<b>Docket Number:</b>	07-AFC-06C
<b>Project Title:</b>	Carlsbad Energy Center - Compliance
<b>TN #:</b>	203084
<b>Document Title:</b>	Supplemental Responses to Data Requests in Set One (Nos. 28-30)
<b>Description:</b>	N/A
<b>Filer:</b>	Dee Hutchinson
<b>Organization:</b>	Locke Lord LLP
<b>Submitter Role:</b>	Applicant Representative
<b>Submission Date:</b>	9/19/2014 3:30:27 PM
<b>Docketed Date:</b>	9/19/2014

Re: Carlsbad Energy Center Project Petition to Amend (07-AFC-06C)  
Project Owner's Supplemental Responses to Data Requests in Set One (Nos. 28 - 30)

## Data Response Set 1 Supplement (Supplemental Responses to Data Requests 28 to 30)

**Figure DR28-3**  
**138kV for CECP COD One Line Diagram**  
 Amended Carlsbad Energy Center Project  
 Carlsbad, California (07-AFC-06C)  
 Petition to Amend

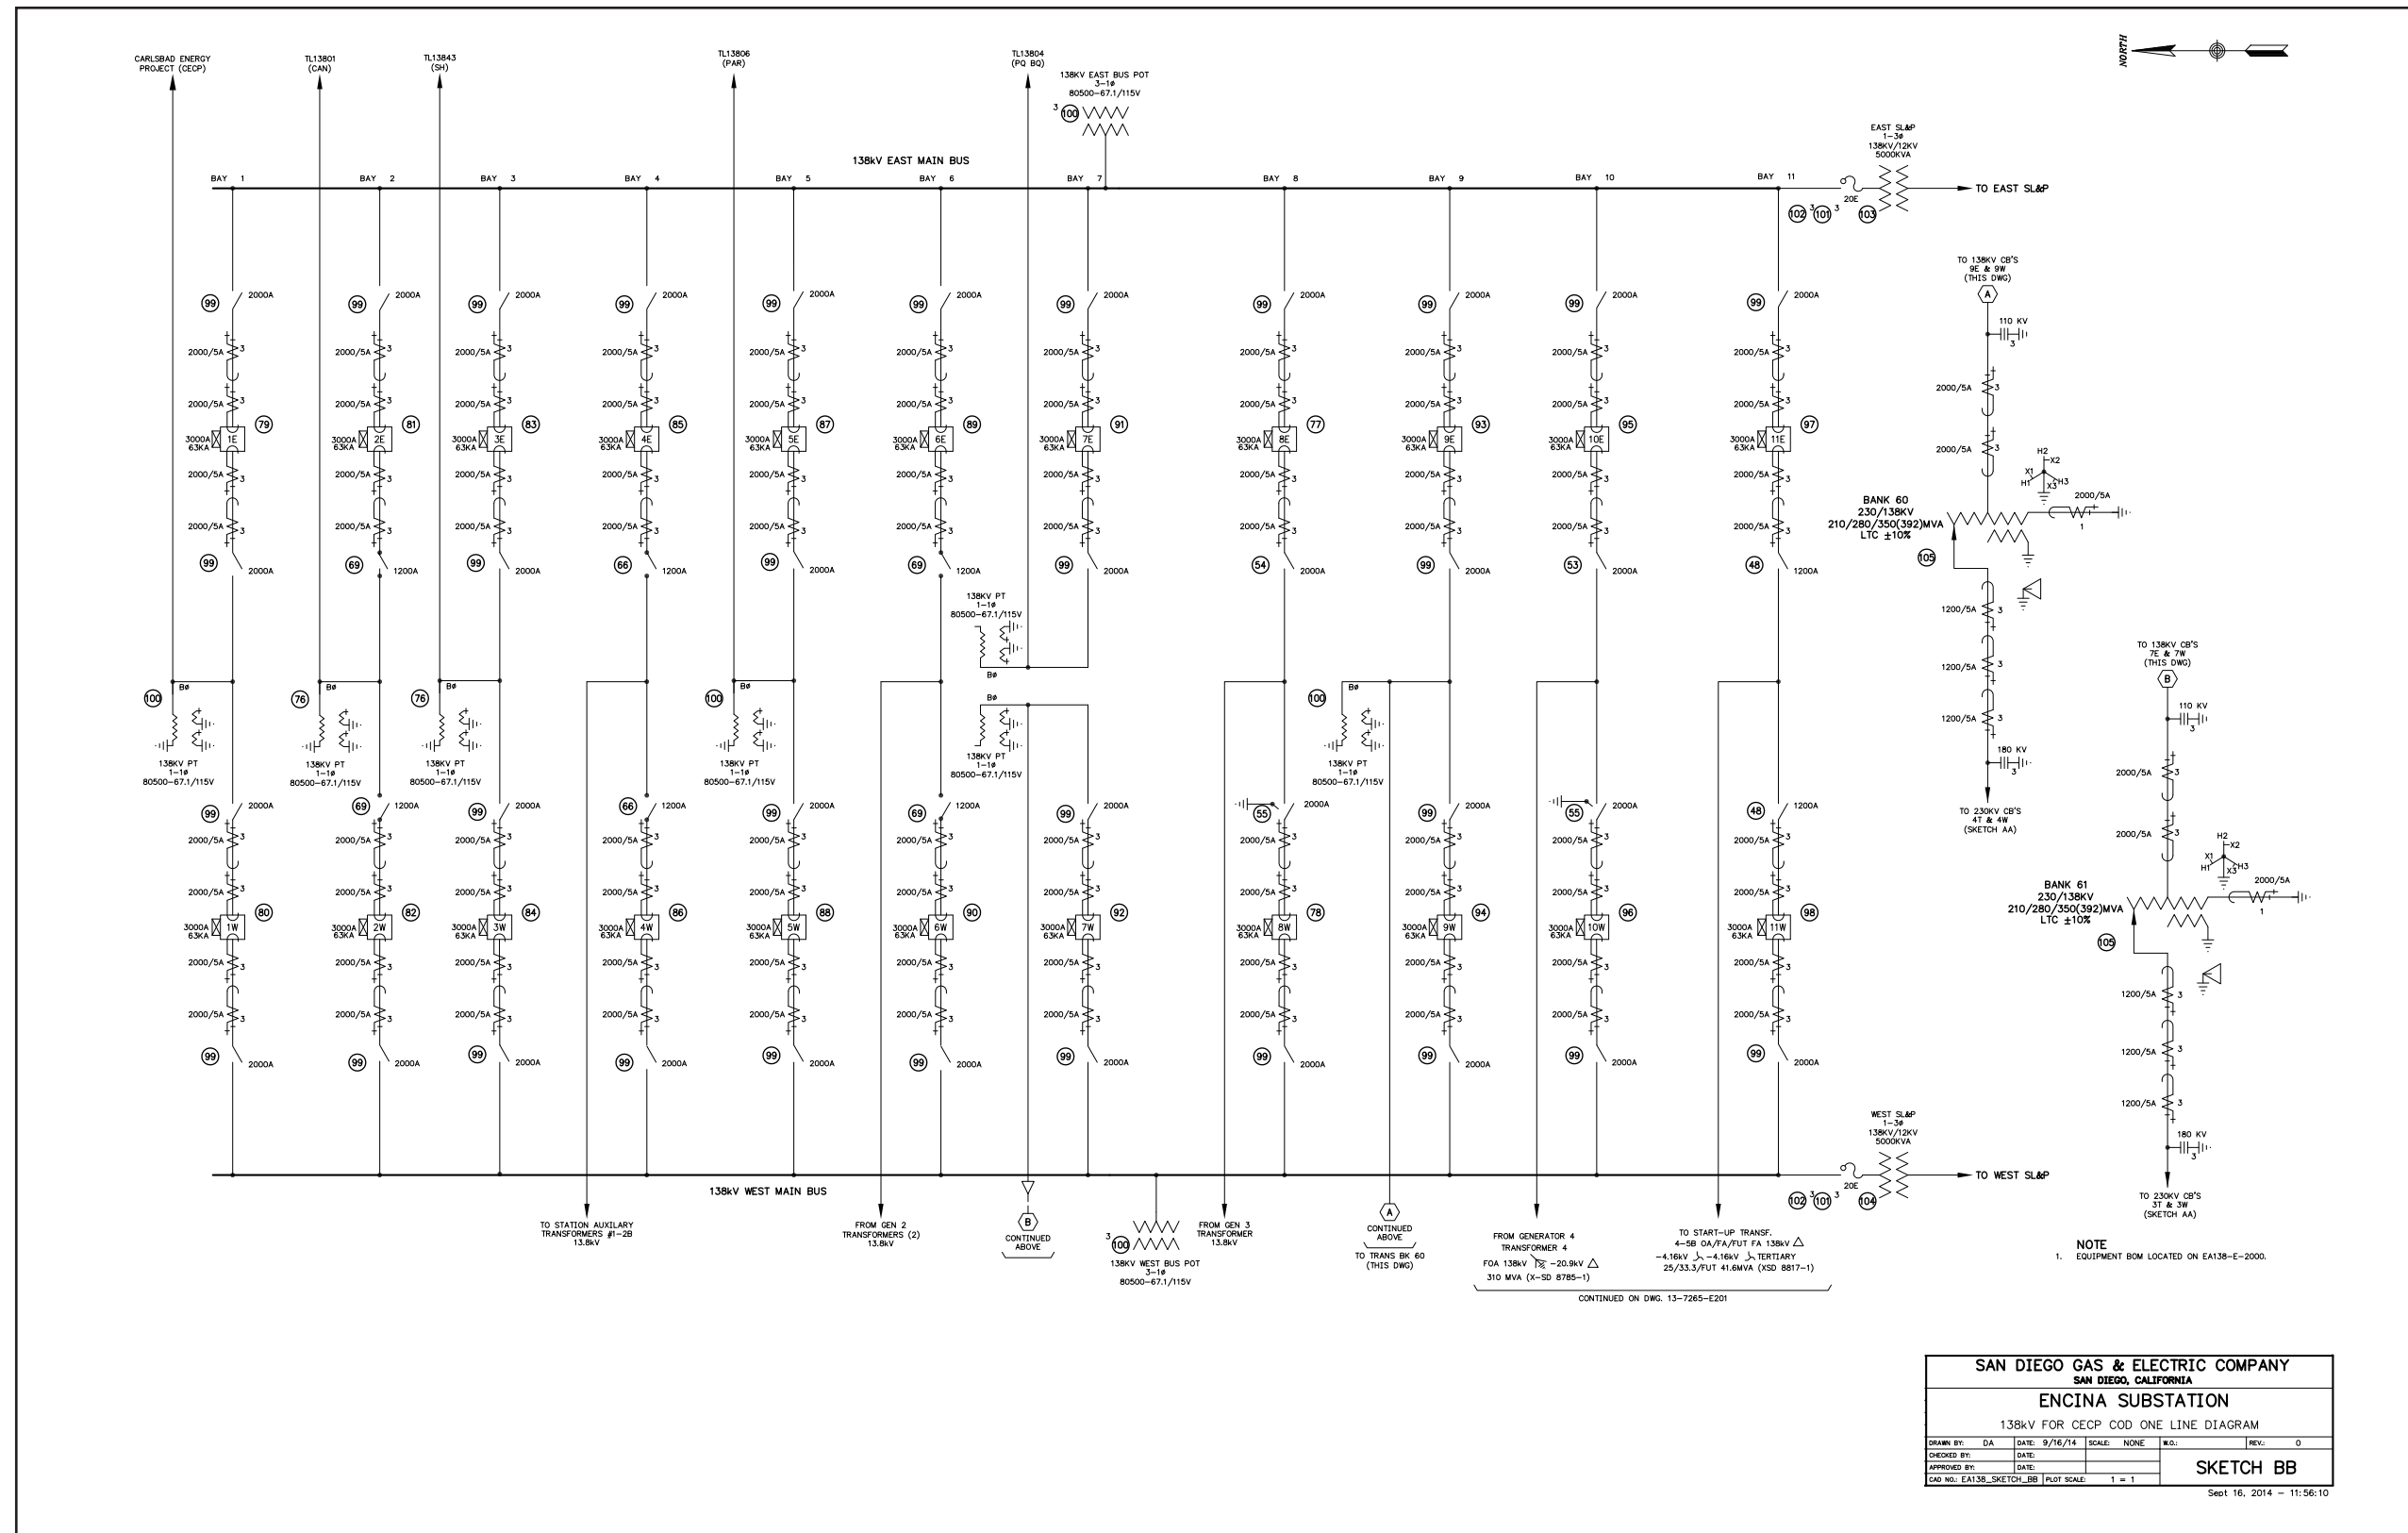
28. Submit pre and post-project electrical one-line diagrams of the existing SDG&E EPS 138 kV and 230 kV switchyards showing configuration of switchyard buses and switching bays (with SB nos.) with breakers and associated disconnect switches with their respective sizes and/or ratings in amperes along with all transmission outlets showing the modifications in the switchyard for interconnection of the overhead 138 kV and the UG 230 kV gen tie lines. In addition, provide post-project electrical one-line diagrams of the SDG&E 138 kV and 230 kV switchyards after the decommissioning of the Encina Power Station (EPS), and disconnection of the existing EPS Units as scheduled in 2017. Fully describe and detail any and all measures proposed to insure transmission infrastructure integrity and the during the EPS demolition activities sought by the in the PTA. Moreover, describe any and all transmission measures and details planned for the seamless and timely transition from EPS Unit electrical generation to that of the Amended CECP.

**Response:** Project Owner provided electrical one line drawings of the existing SDG&E EPS 138 kV and 230 kV switchyards in Project Owner's August 15, 2014 responses to CEC staff's Data Response Set 1. Project Owner has since received electrical one-line drawings of (a) the post-Commercial Operation Date configurations of the 138kV and 238kV SDG&E switchyards, which are enclosed as Figures DR28-3 and DR28-4, respectively; and (b) of the ultimate arrangements of these switchyards, which are enclosed as Figures DR28-5 and DR28-6, respectively.

As Project Owner previously explained, to ensure a seamless and timely transition from EPS electrical generation to CECP electrical generation in the Encina Switchyard, EPS Unit 1 will cease operation before the 138kV commissioning of CECP. EPS Unit 1 will be disconnected from Bay Position 2, and SDG&E will move an outgoing line from Bay Position 1 to Bay Position 2, thereby opening up Bay Position 1 for the new CECP 138kV connection. Similarly to the Licensed CECP, this is the only position that requires these procedural steps. In the 230kV portion of the Encina Switchyard, SDG&E will take necessary actions to ensure that a breaker position is available for the new 230kV line from the Amended CECP, thereby preventing interference with existing EPS unit connections.

Figure DR29-2  
 Ultimate Arrangement for CECP COD  
 Amended Carlsbad Energy Center Project  
 Carlsbad, California (07-AFC-06C)  
 Petition to Amend

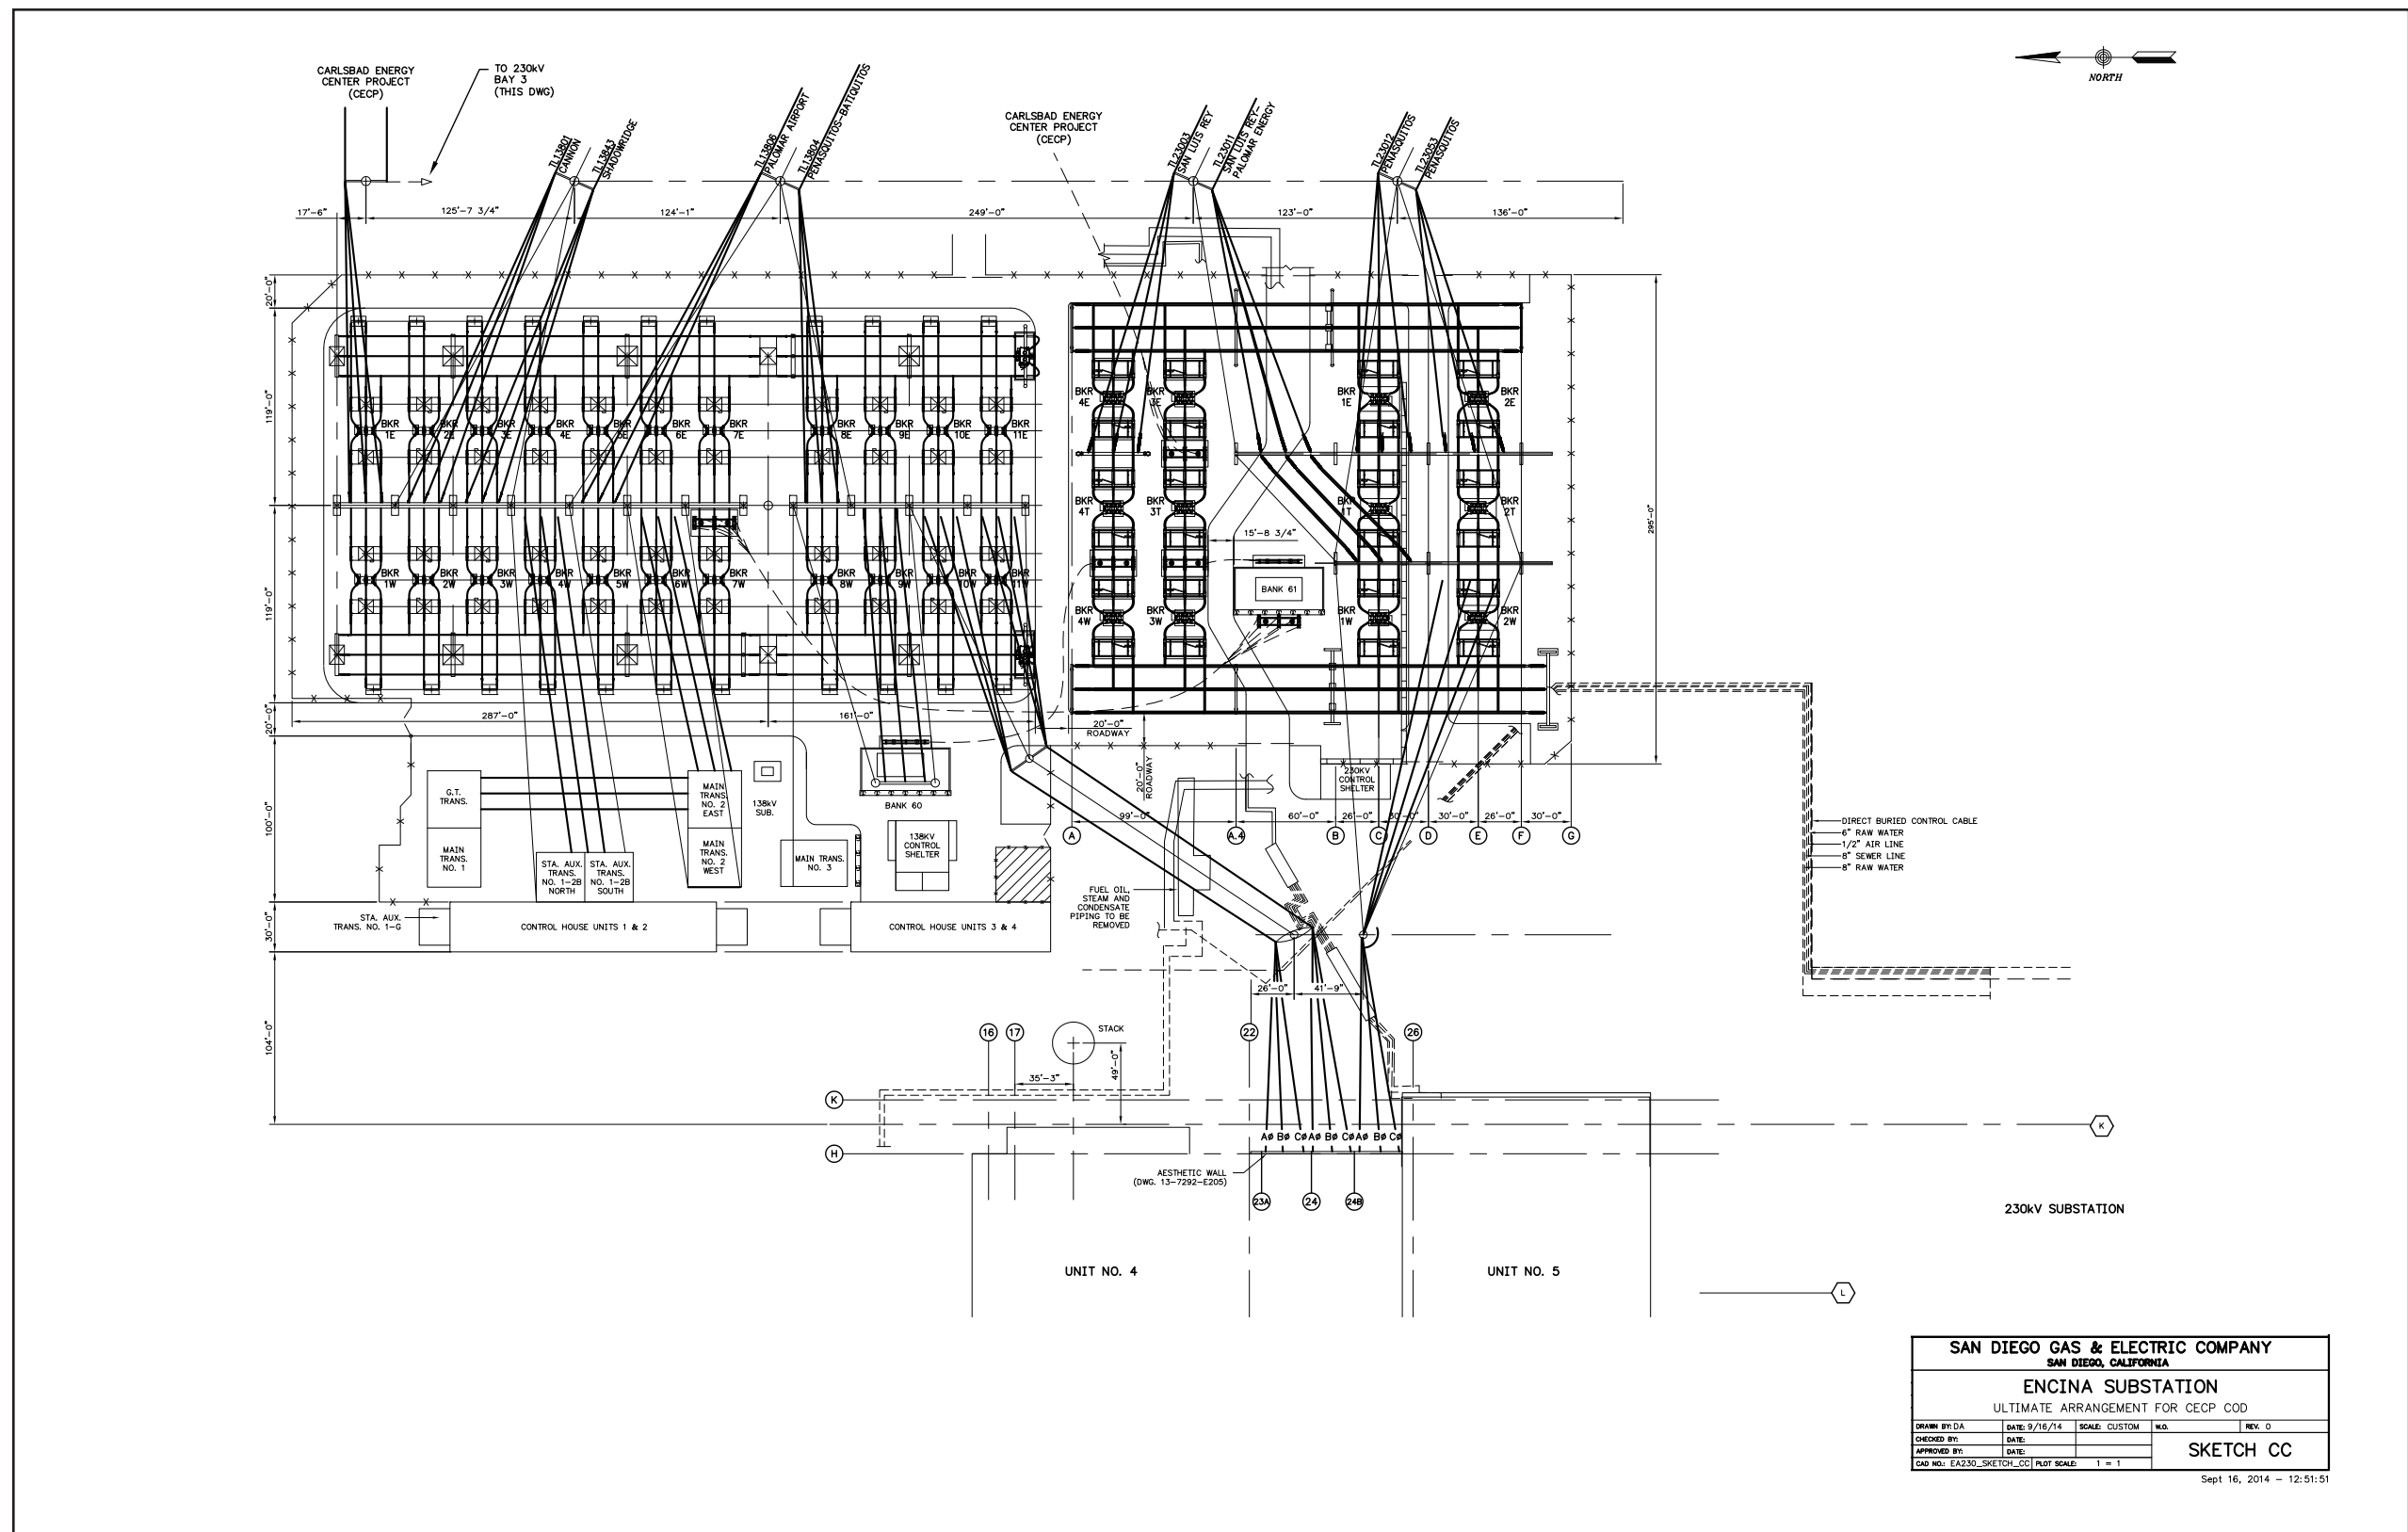
29. Provide pre and post-project physical layout drawings of the SDG&E EPS 230 kV and 138 kV switchyards, with all transmission outlets.

**Response:** A drawing of the post-Commercial Operation Date, general physical layout of the SDG&E 230kV and 138kV switchyards are enclosed as Figure DR29-2. The general final arrangement drawing for the 138/230kV switchyards are enclosed as Figure DR29-3.
